# **FIRE SAFETY INSPECTION REPORT**

**HANNAN KNITWEARS LIMITED**

**ACCORD ID: 12176**

April 11, 2015

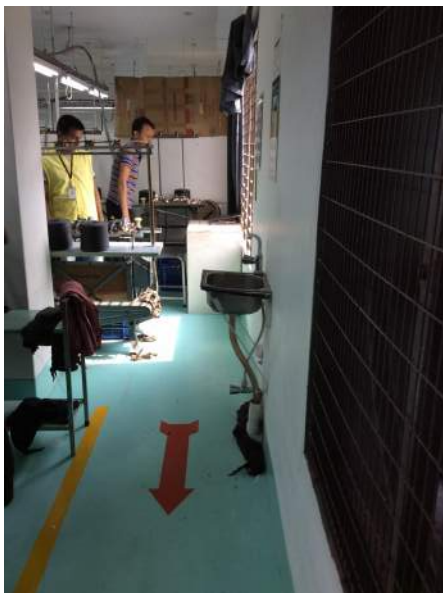
F-11	Egress	Egress doors with locking features are provided along egress routes and exit stairs. Egress gates with locking features are provided at exit stairs. All doors were not open and unlocked during the inspection.	Remove locking features from all egress doors and gates.  If locks are required for security reasons, utilize special door locking features complying with NFPA 101 and ACCORD standard 6.8.2.	Immediately
------	--------	--	--	-------------

F-15 Egress

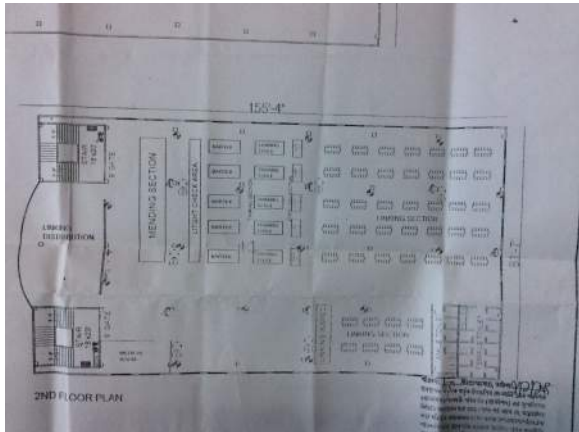
The width of egress aisles is less than 36-in. on all floors except first floor and roof top.

Provide minimum aisle widths of 36-in.

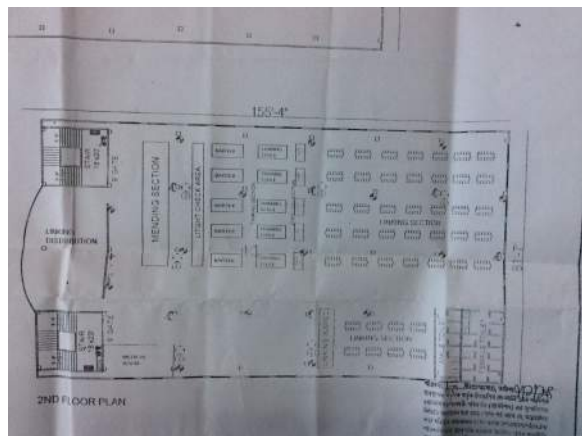
F-19	Egress	The exits are not remotely located from each other such that a single fire event could compromise both exits on all floors.	Provide additional exit to meet ACCORD standard 6.6.6.	Within 6 months
------	--------	---	--	-----------------

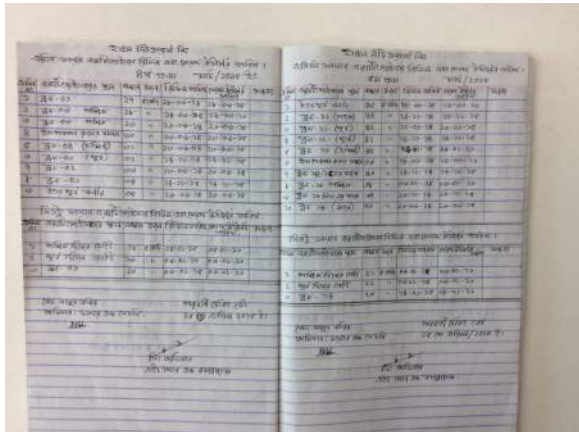
F-20	Fire Protection	Inspection, testing and maintenance of portable fire extinguishers is not in accordance with NFPA 10.	Inspect, test and maintain the portable fire extinguishers and keep written records on-site, in accordance with NFPA 10.	Within 3 months
------	-----------------	---	--	-----------------

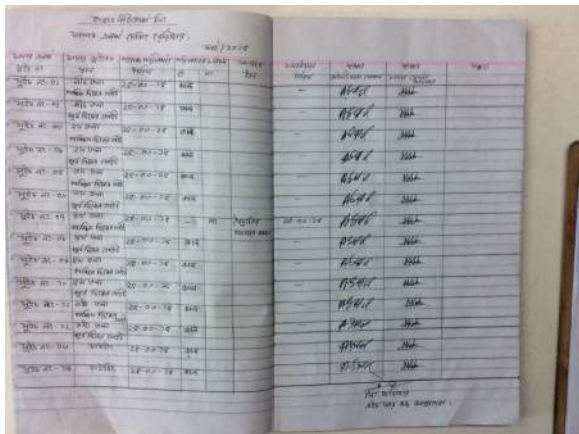
F-21	Fire Protection	Inspection, testing and maintenance for the fire alarm system is not in accordance with NFPA 72.	Inspect, test and maintain the fire alarm system and keep written records on-site, in accordance with NFPA 72.	Within 3 months
------	-----------------	--	--	-----------------
